**SAFETY EVALUATION OF
PROPOSED TECHNICAL SPECIFICATION CHANGES ASSOCIATED WITH
PRESSURE-TEMPERATURE AND OVERPRESSURE PROTECTION SYSTEM
LIMITS FOR UP TO 13 EFFECTIVE FULL POWER YEARS**

NEW YORK POWER AUTHORITY
INDIAN POINT 3 NUCLEAR POWER PLANT
DOCKET NO. 50-286
DPR-64

**MARK-UP OF TECHNICAL SPECIFICATION PAGES ASSOCIATED WITH
AMENDMENT REQUEST FOR PROPOSED TECHNICAL SPECIFICATION CHANGES
ASSOCIATED WITH PRESSURE-TEMPERATURE AND OVERPRESSURE PROTECTION
SYSTEM LIMITS FOR UP TO 13 EFFECTIVE FULL POWER YEARS**

Figure 2.1
Reactor Coolant System Heatup Limitations

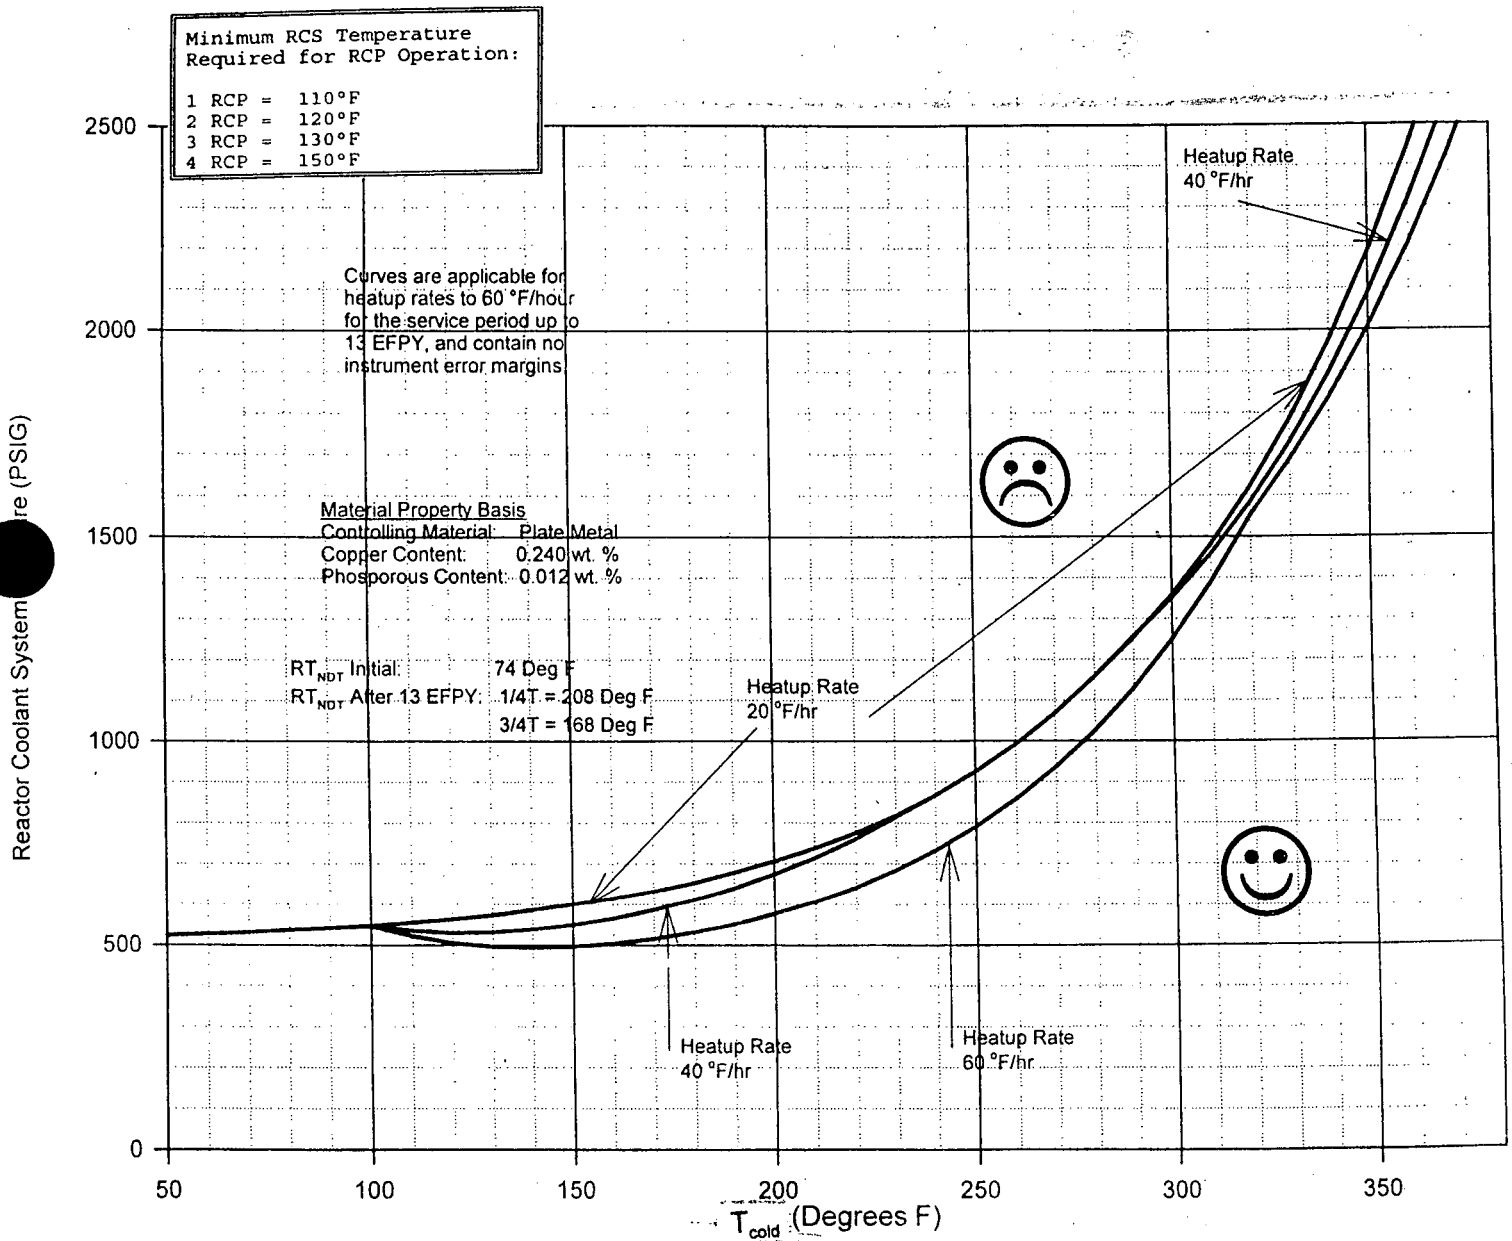
2. The limit lines shown in ~~Figure 3.1-1 and Figure 3.1-2~~ **PTLR Figures 2.1 and 2.2** shall be recalculated periodically using methods discussed in the Basis and results of surveillance specimens as covered in Specification 4.2. The order of specimen removal may be modified based on the results of testing of previously removed specimens.

Because operation control is on coolant temperature, and cooldown rate may vary during the cooldown transient, the limit curves shown in Figure 3.1-2 2.2 of the PTLR represent a composite curve consisting of the more conservative values calculated for steady state and the specific cooling rate shown.

Figure 2.2
Reactor Coolant System Cooldown Limitations

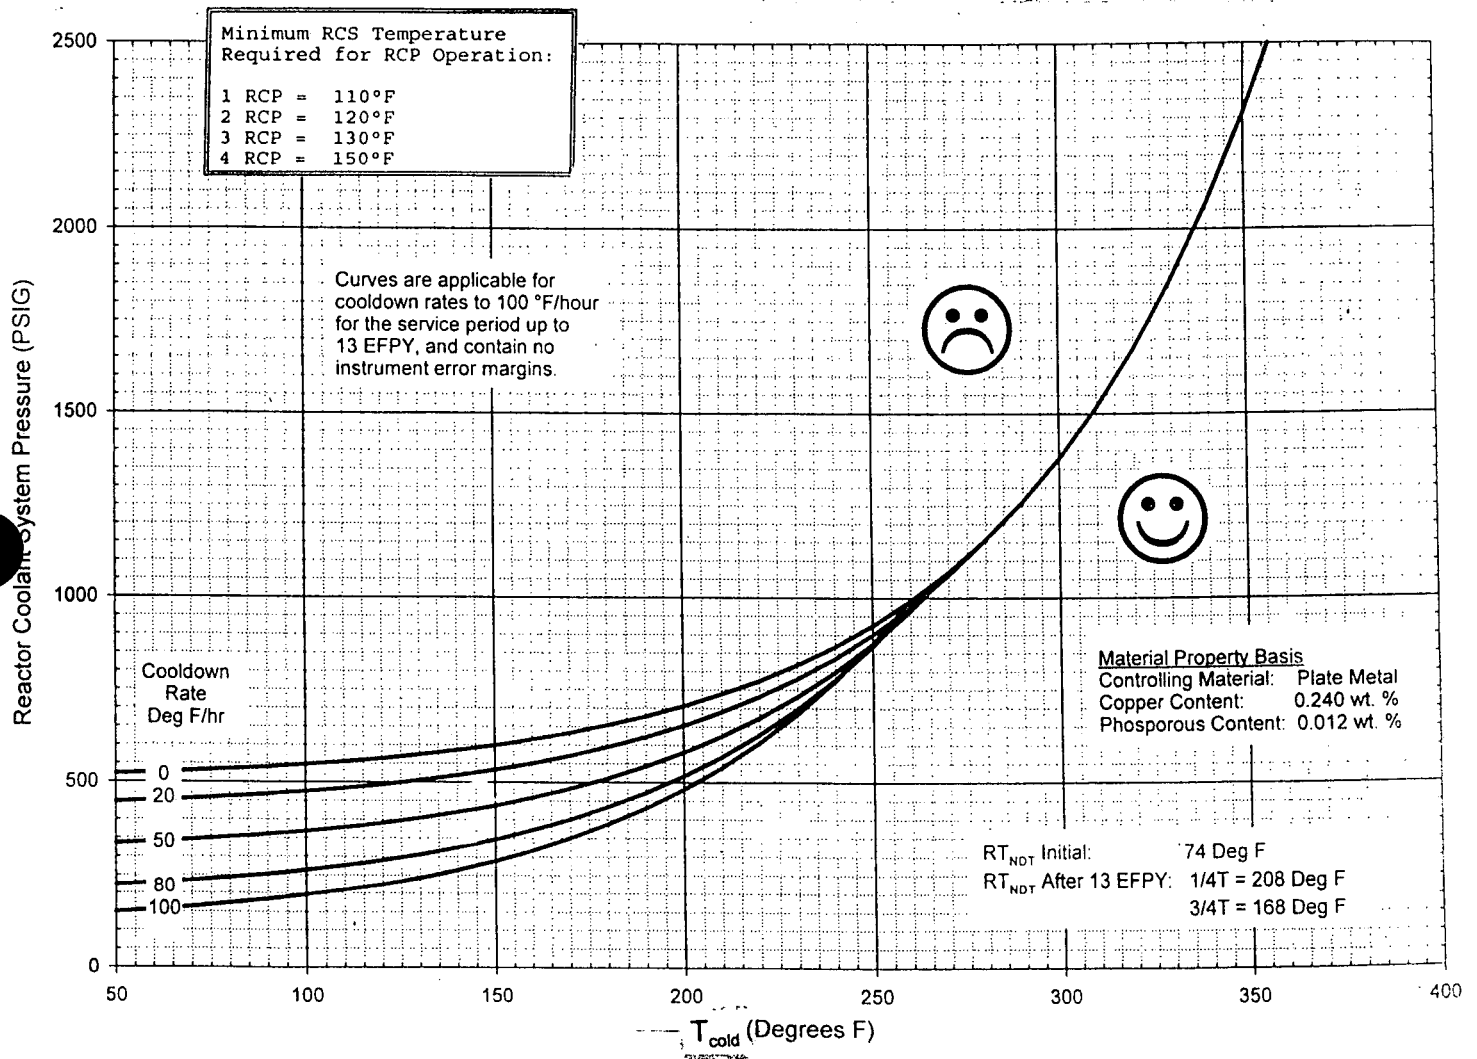
- a) The Reactor Coolant System shall be tested for leakage at normal operating pressure prior to plant startup following each refueling outage, in accordance with the requirements of ASME Section XI.
- b) Testing of repairs, replacements or modifications for the Reactor Coolant System shall meet the requirements of ASME Section XI.
- c) The Reactor Coolant System leak test temperature-pressure relationship shall be in accordance with the limits of Figure ~~4.3-1 for heatup for the first 11.00 EFPYs of operations~~ **2.7 in the PTLR for the applicable service period.** ~~Figure 4.3-1~~ **This figure** will be recalculated periodically. Allowable pressures during cooldown from the leak test temperature shall be in accordance with Figure ~~3.1-2~~ **2.2 in the PTLR.**

Figure 2.3
Maximum Allowable Nominal PORV Setpoint for the
Low Temperature Overpressure Protection System (OPS), 13 EFPY

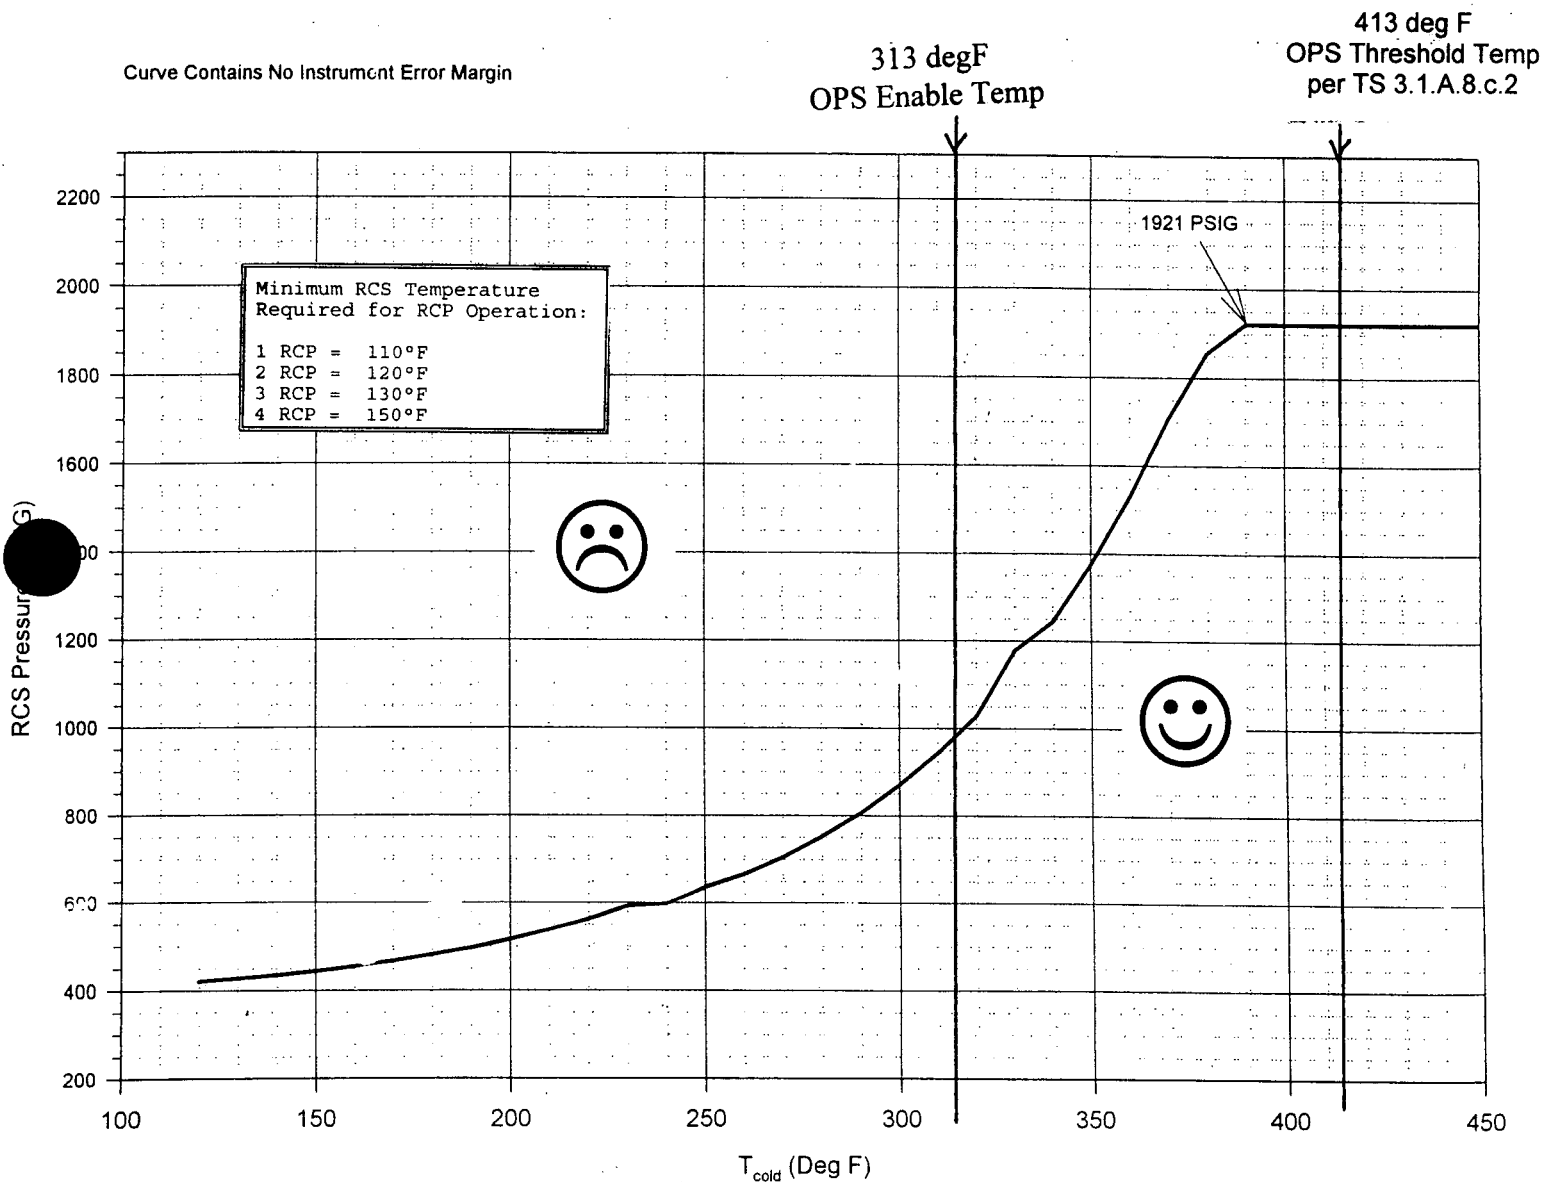
1. the OPS shall be armed and operable. Both OPS PORVs shall have lift settings not to exceed those given in Figure 2.3 of the PTLR, or
 2. the RCS must be vented with an equivalent opening of 2.0 square inches.

- (2) The RCS must be heated in accordance with the **restrictions of Specifications Specification 3.1.A.1.h(3) and (4)** and maintained above 370°F the maximum OPS

threshold temperature defined in Figure 2.3 of the PTLR;

Figure 2.4
Secondary Side Limitations for RCP Start with Secondary Side Hotter Than Primary, 13 EFPY

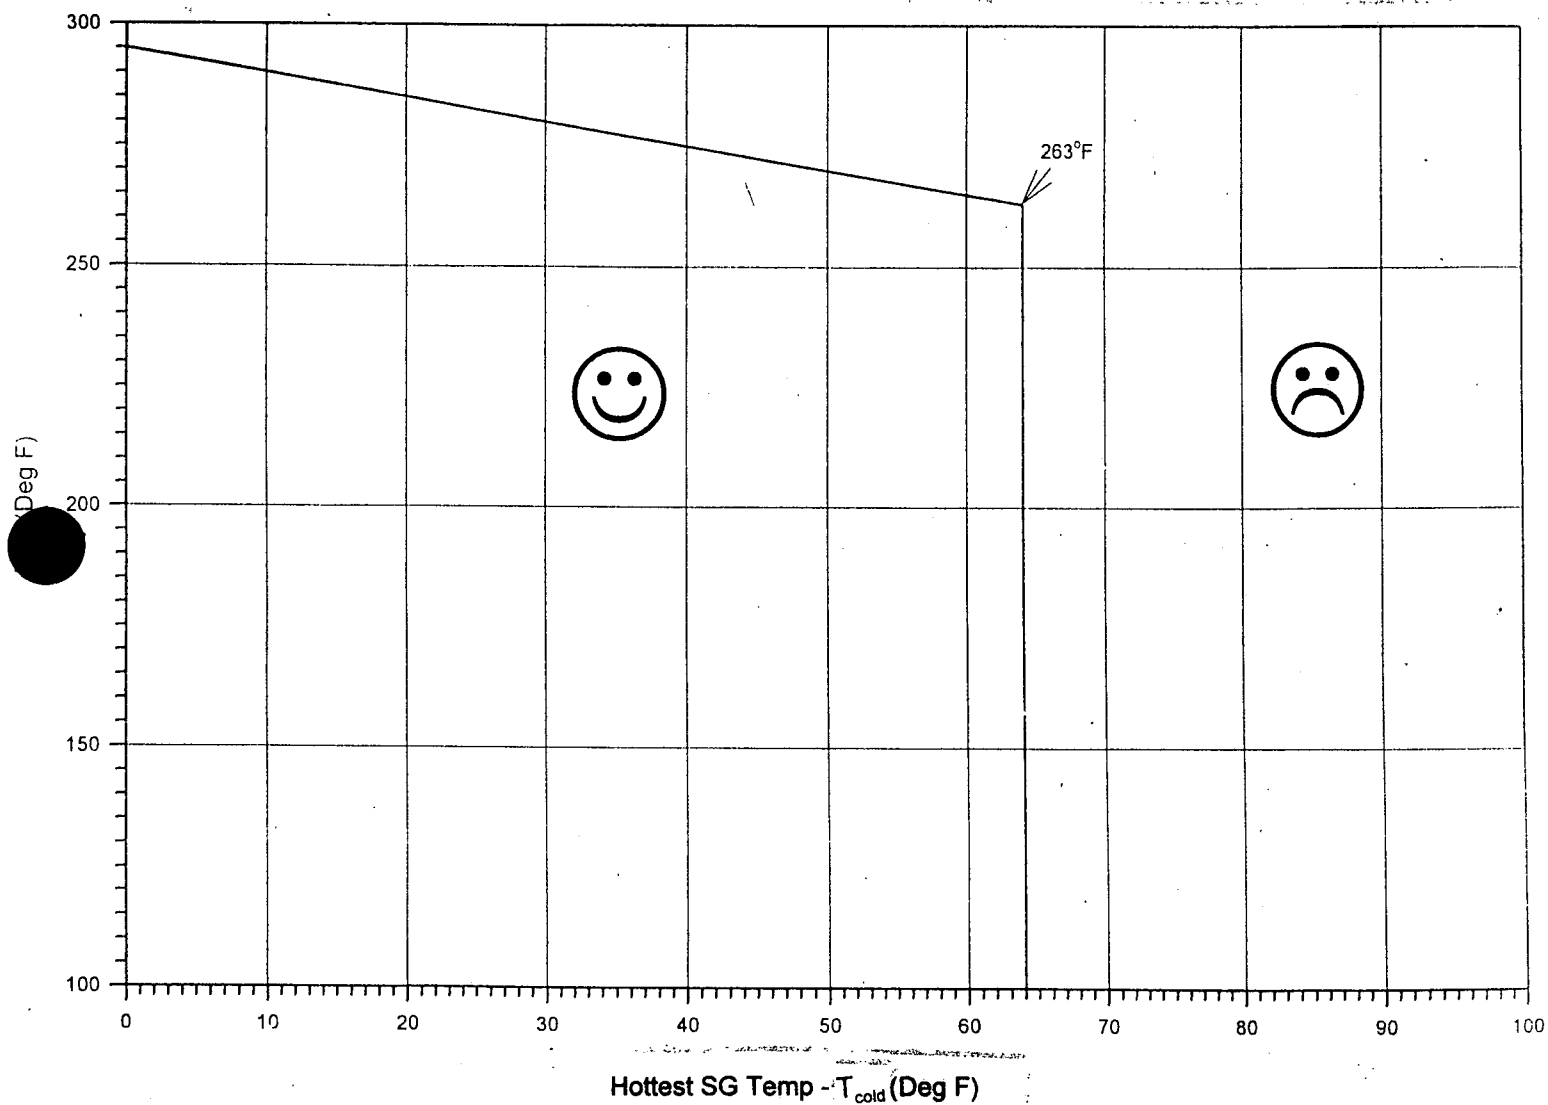
- (2) The OPS is operable, the temperature of the hottest steam generator exceeds the coldest T_{cold} by no more than 64°F, pressurizer level is at or below 75 73 percent, and T_{cold} is as per Figure ~~3.1.A-1~~ **2.4 in the PTLR;**

Figure 2.5
Pressurizer Limitations for OPS Inoperable
(up to one charging pump capable of feeding RCS), 13 EFPY

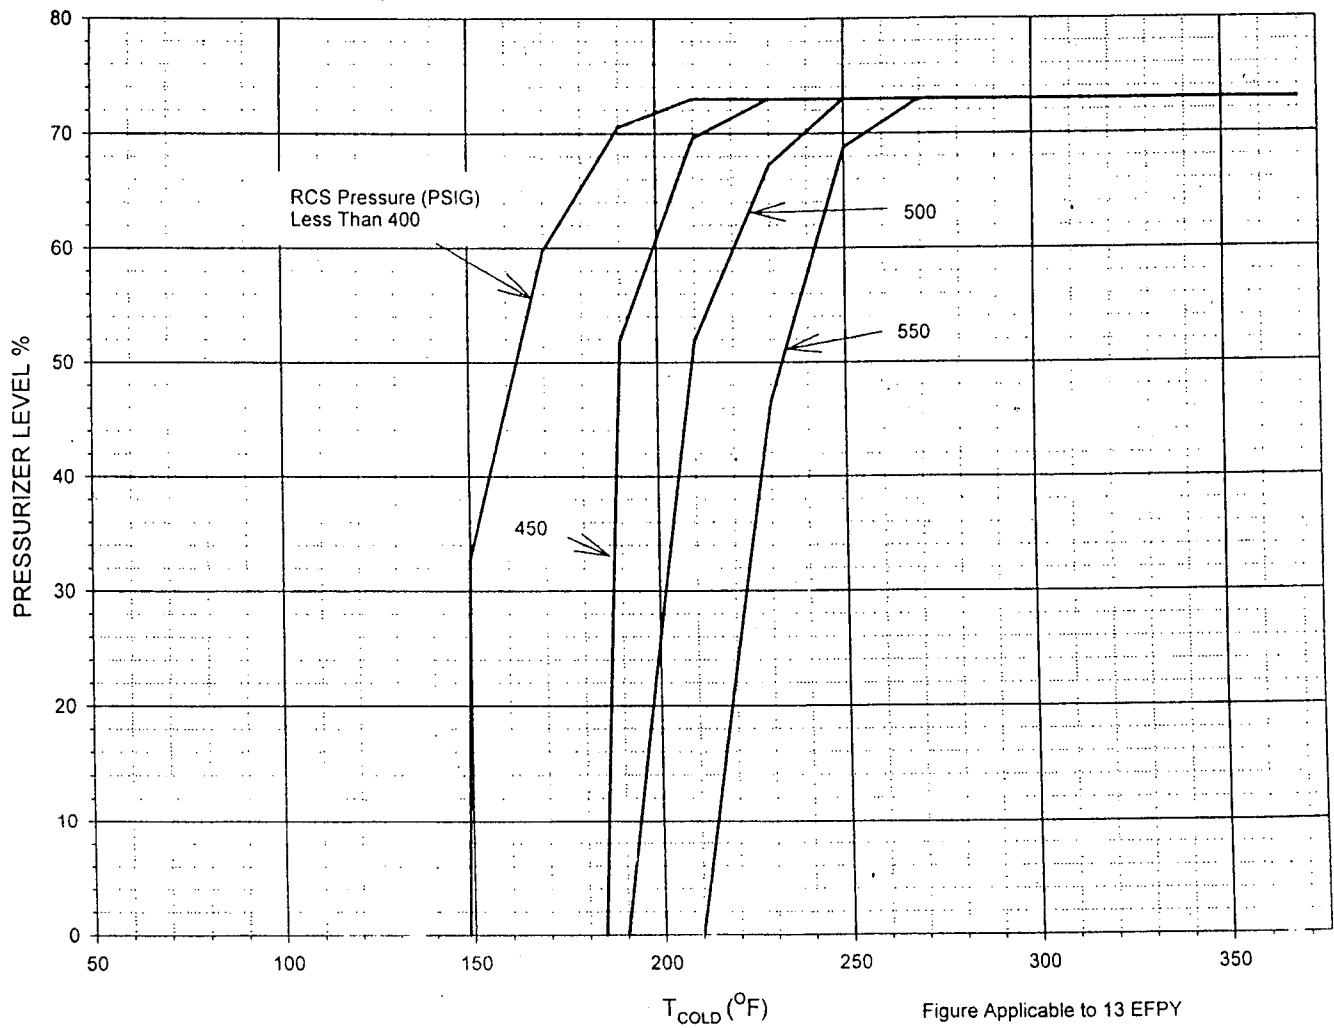
- (3) Restrict pressurizer level as per the curves referenced below: on Figures 2.5 and 2.6 of the PTLR.

Figure 2.6
Pressurizer Limitations for OPS Inoperable (up to three charging pumps
and/or one safety injection pump capable of feeding RCS), 13 EFPY

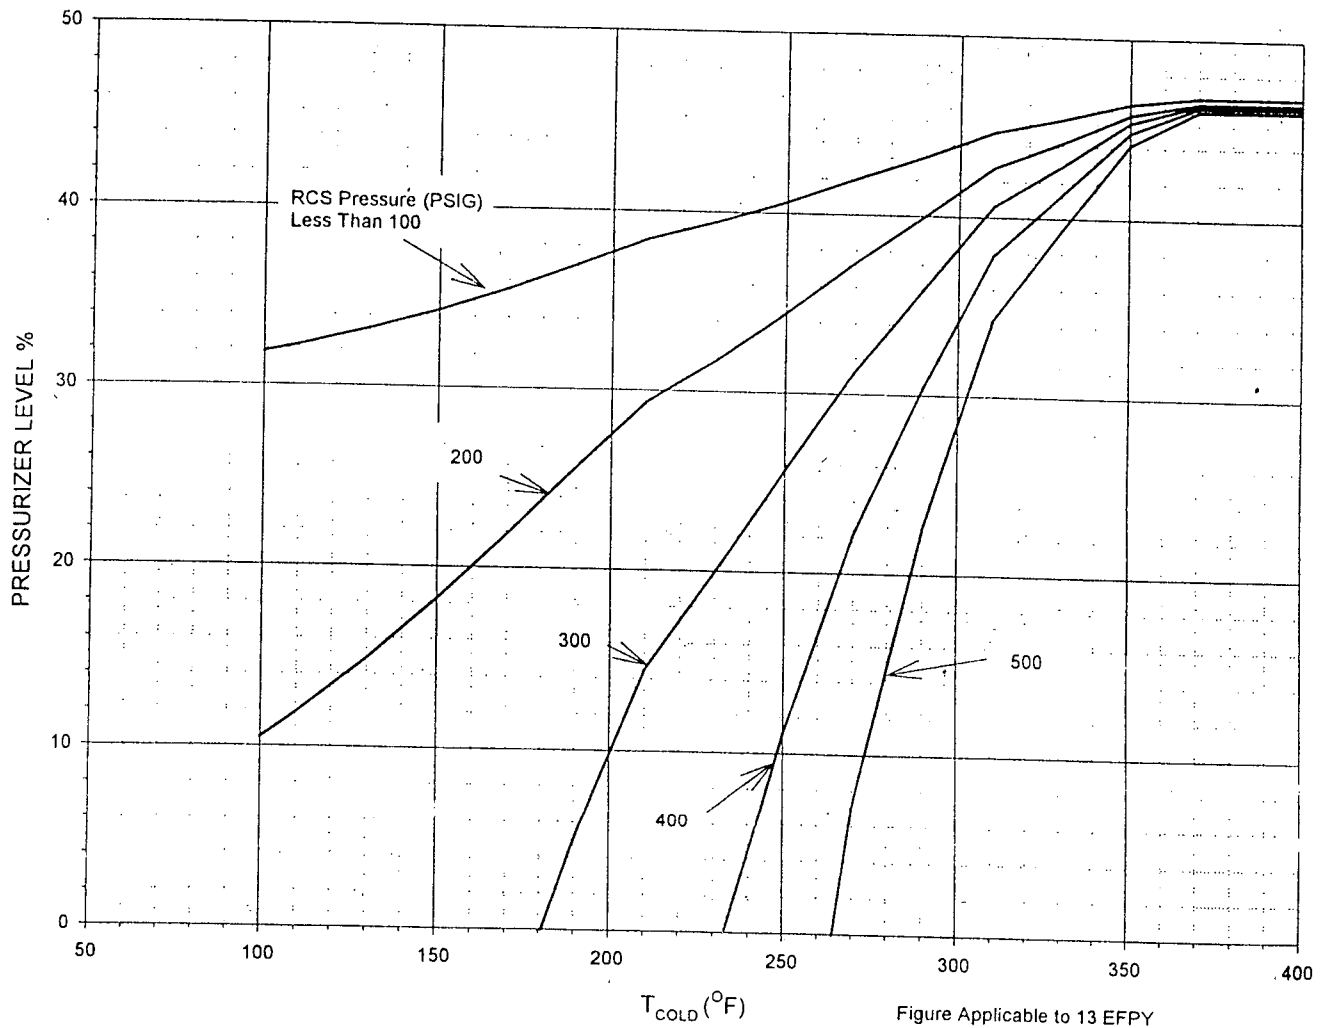
- (3) The OPS is inoperable, steam generator pressure is not decreasing, the temperature of each steam generator is less than or equal to the coldest T_{cold} , pressurizer level is at or below 75 73 percent, and the RCS pressure does not exceed that given by ~~Curve I on Fig. 3.1.A-2~~ **Figure 2.3 in the PTLR. The pressurizer level must be restricted per Figures 2.5 and 2.6 of the PTLR if operation below the OPS enable temperature exceeds 8 hours.**
